VILLAGE OF CALEDONIA UTILITY DISTRICT MEETING AGENDA

Wednesday, January 26, 2022 at 6:00 p.m.

RE: O'Malley Investments – 4526 Northwestern Avenue – Storm Water
Management Plan & Grading Plan for Land Disturbance Permit Conditional
Approval

RE: Prairie Pathways Phase IV Utility & Grading Plan Conditional Approval

2019.0131.01
SHEET
C-8

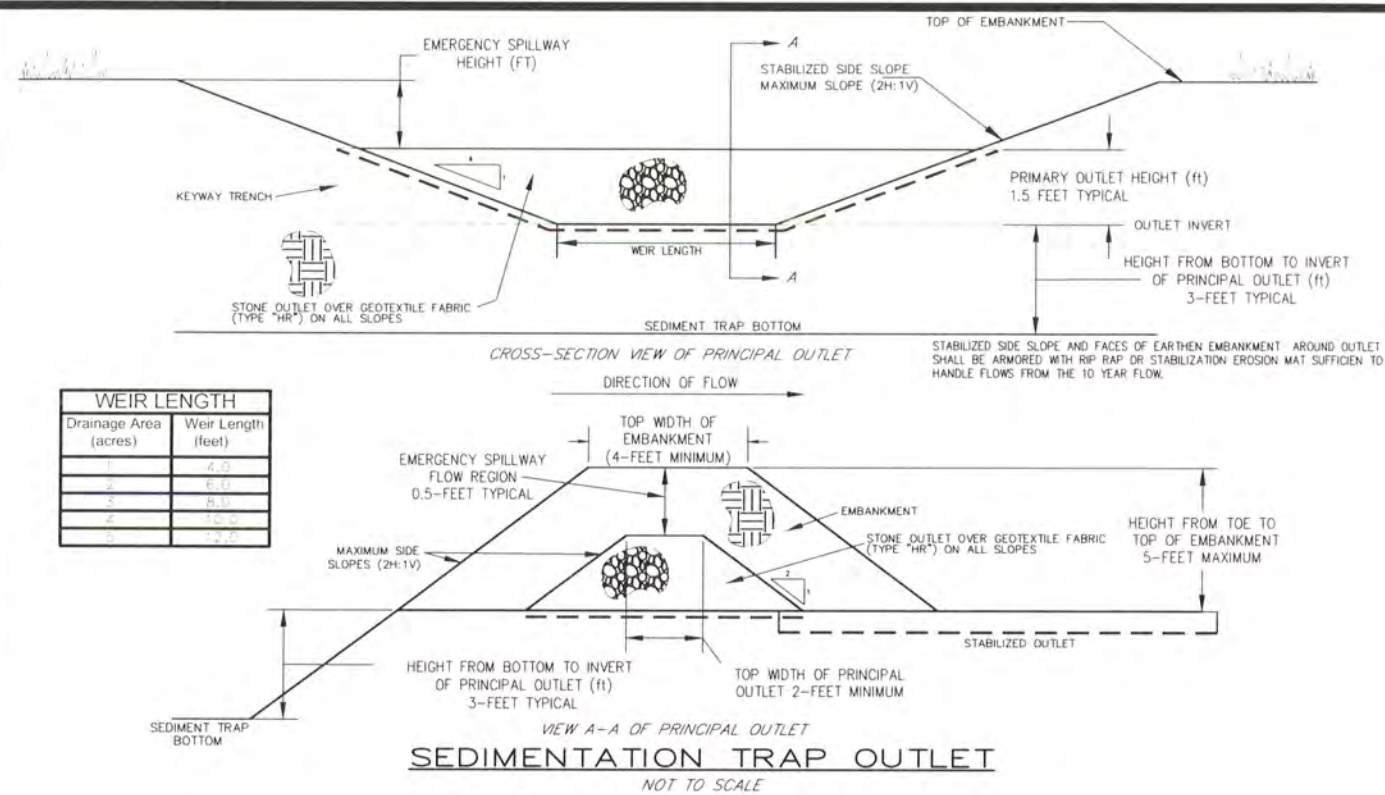
- Provide a copy of the WDNR WRAPP (NOI).
- Complete a Village of Mount Pleasant Storm Water Permit.
- Obtain WisDOT access Permits as necessary.
- Adjust the 100-year High water elevation on the pond profile (Sheet C-8).

REVISIONS		SHEET 7 OF 13
1.	PER VILLAGE COMMENTS 10.18.21

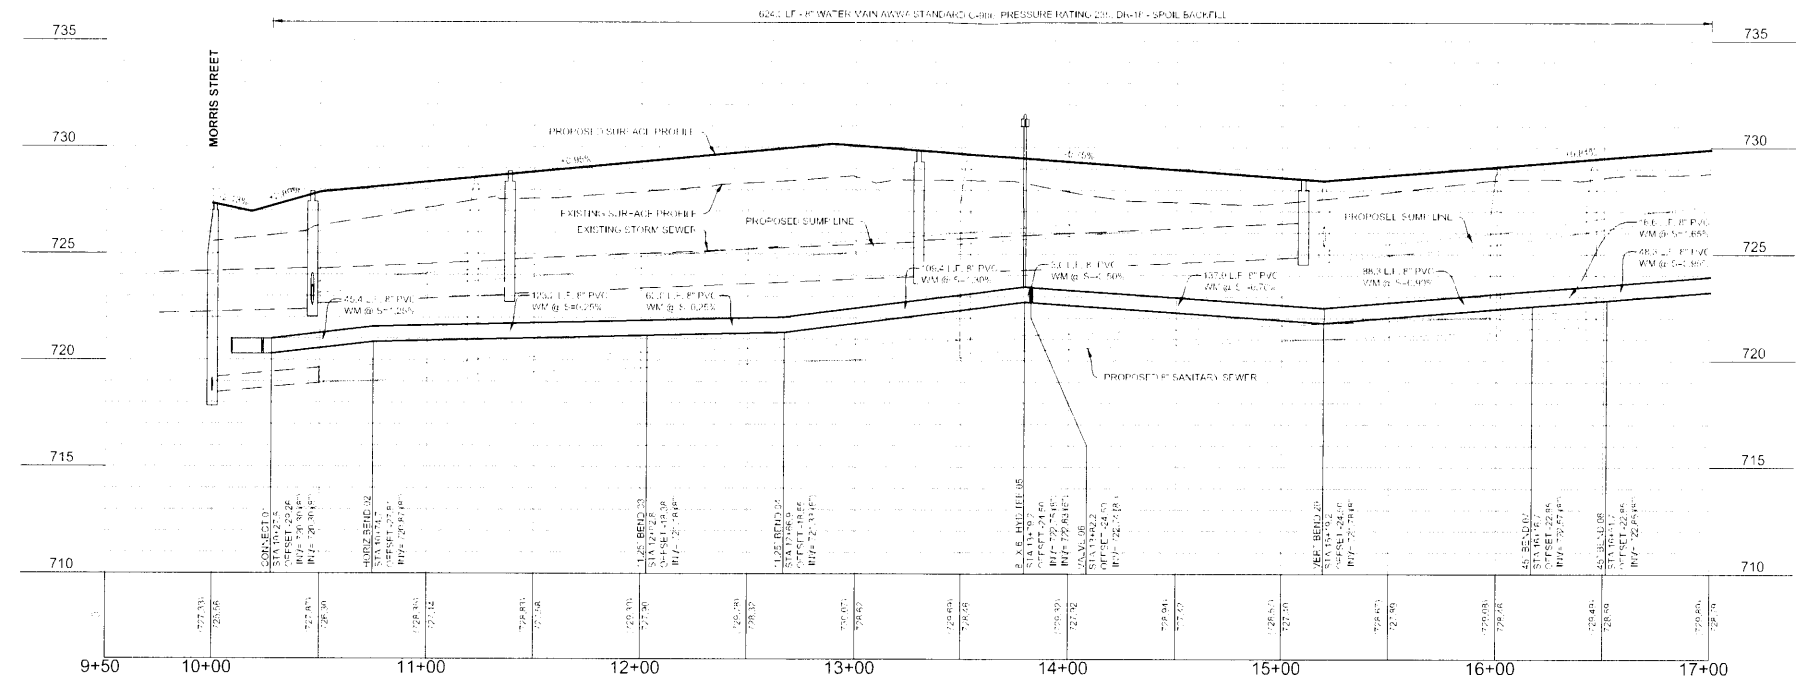
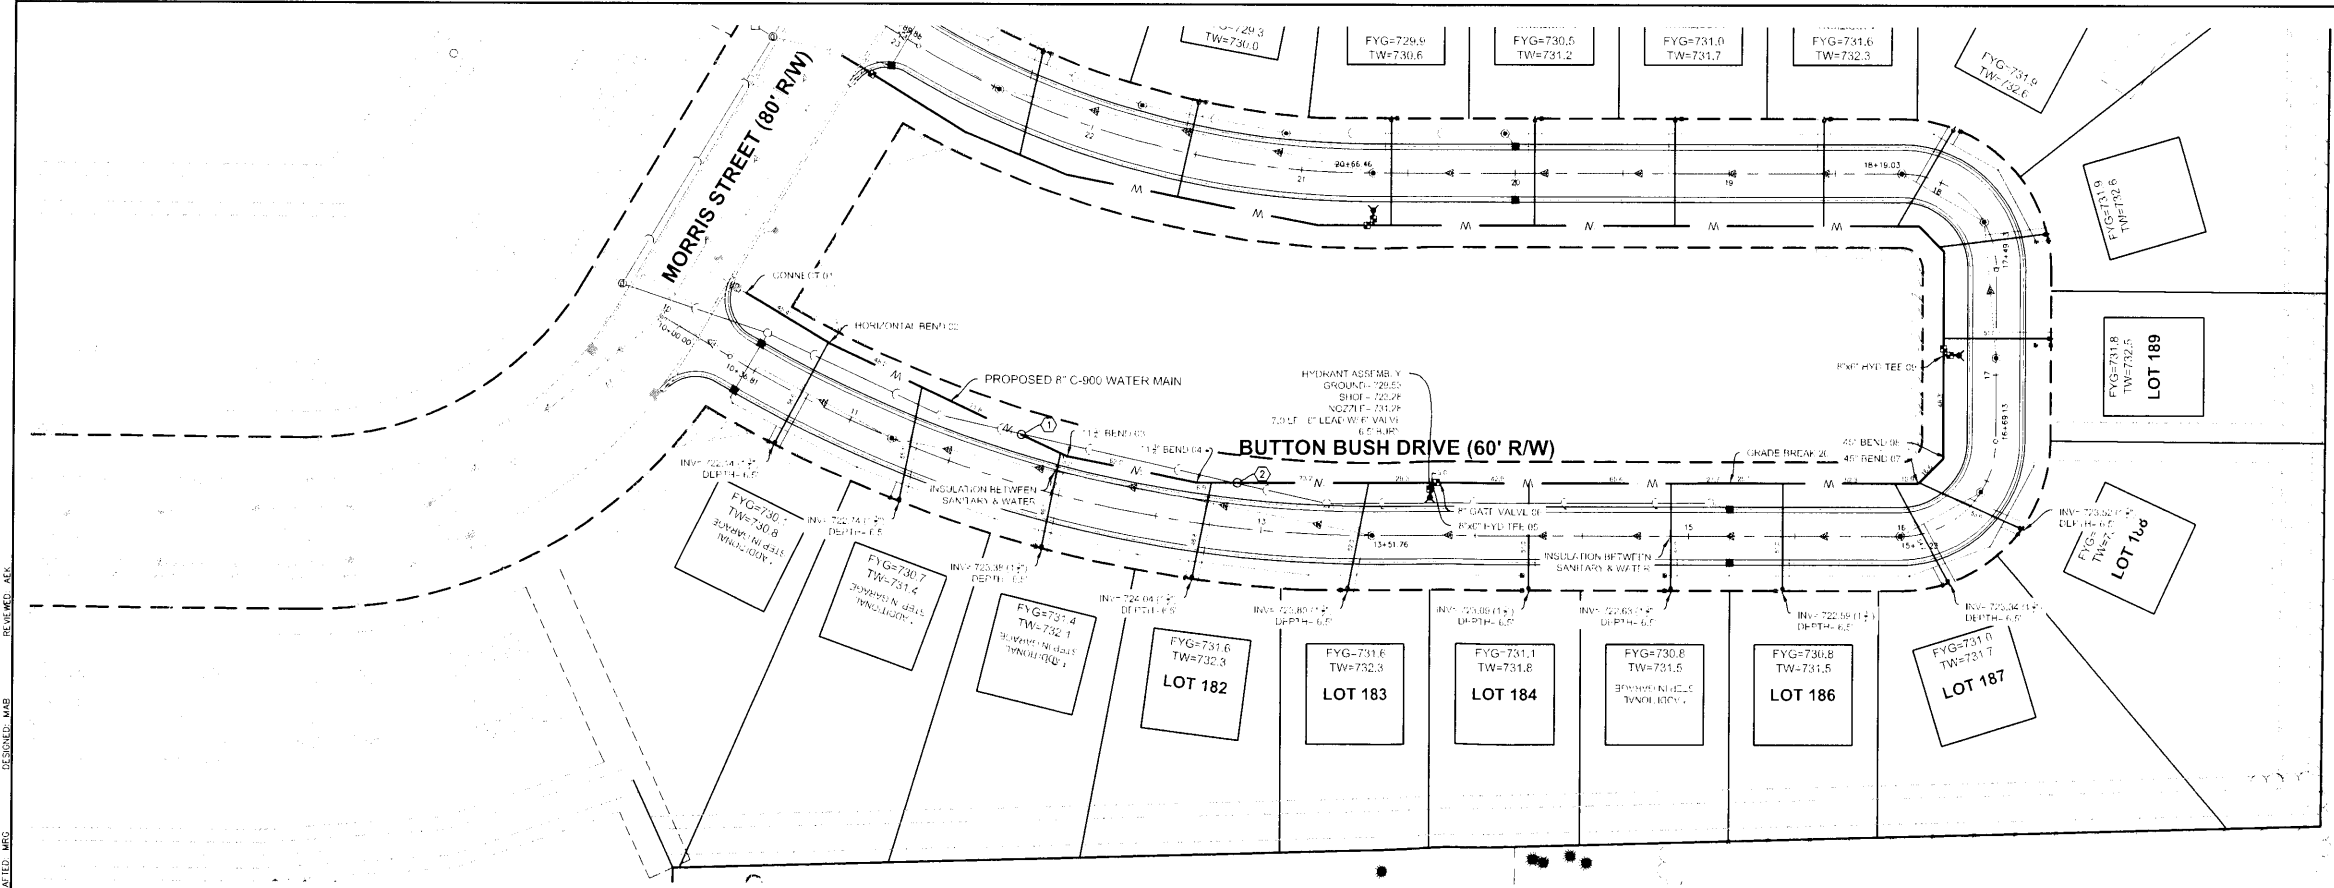
- On Sheets 5, 7 & 11 will need to label lots as necessary.
 - Sheets 5 & 7 label 179,180, 181, 190 & 191.
 - Sheet 11 label 185 & 186.
 - On Sheet 13 of 13 The base course of the road shall extend beyond the back of curb by a minimum of 18".

REVISIONS		SHEET
NO.	DESCRIPTION	
1	PER VILLAGE COMMENTS 12.18.21	8 OF 13

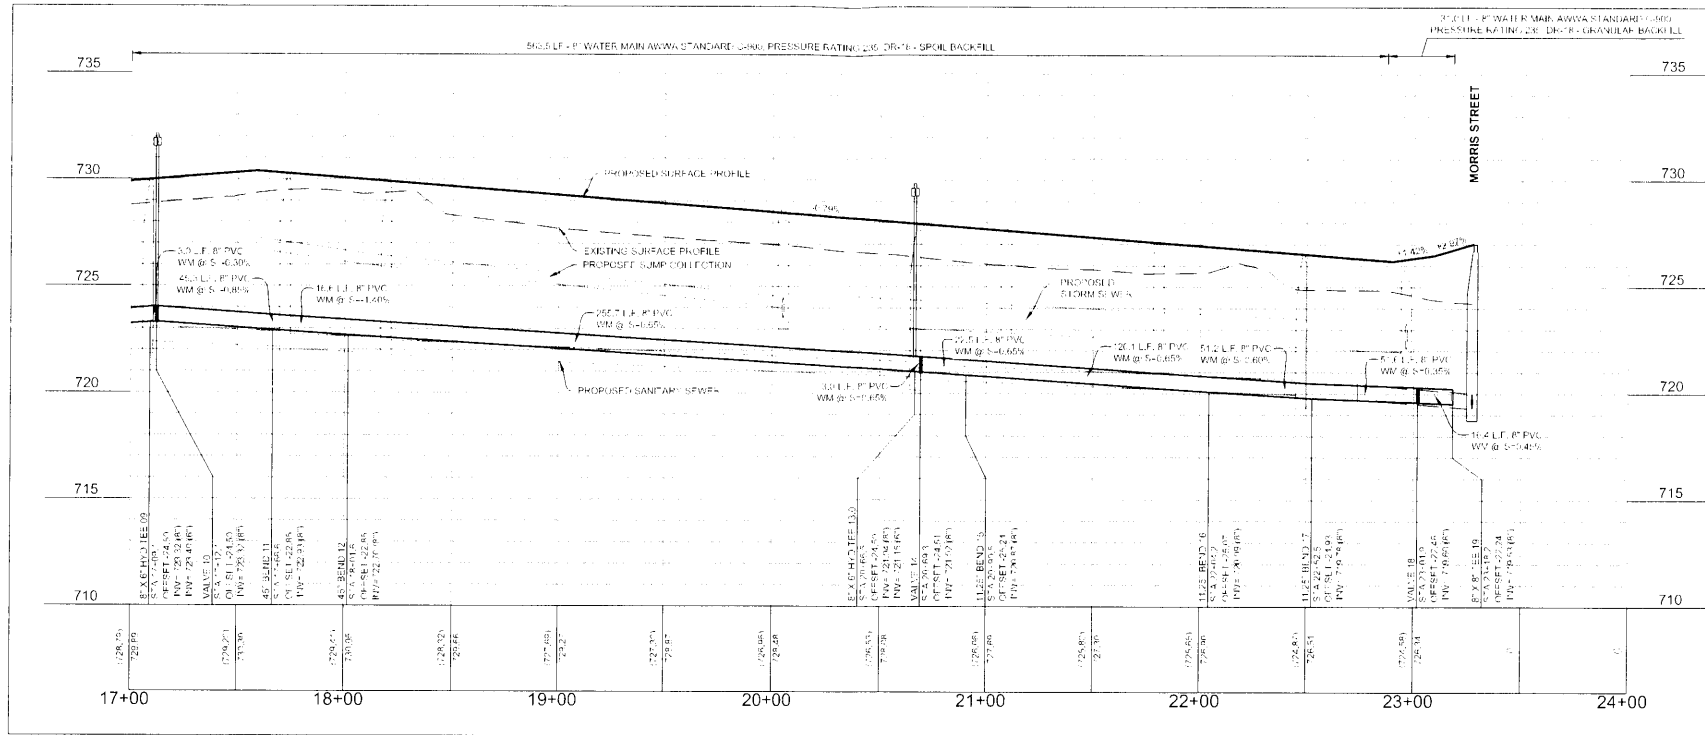
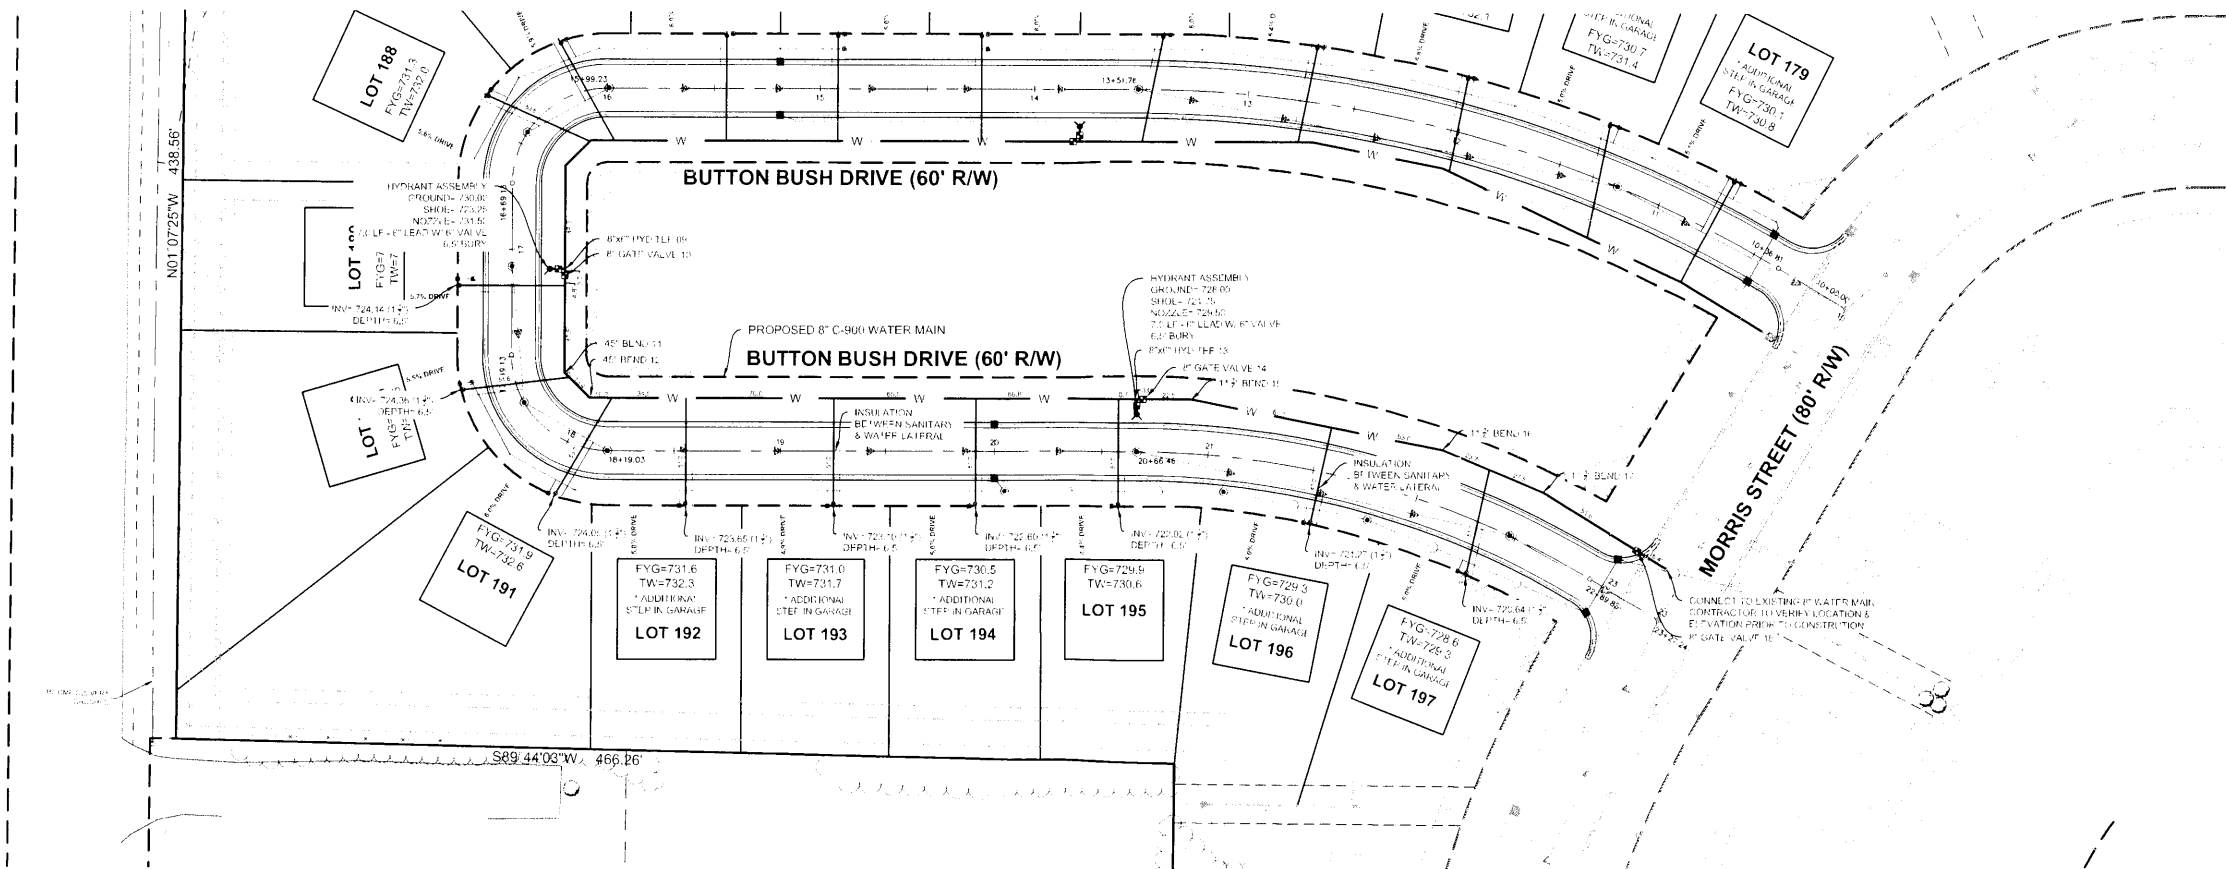
- Watermain
 - The watermain and sanitary sewer are close in elevation from STA 17+00 to 23+25. They added two notes to the plan view on Sheet 8 regarding the insulation you requested. I would recommend they make that note say "(TYP)" for all water services shown on Sheet 8 of 13.
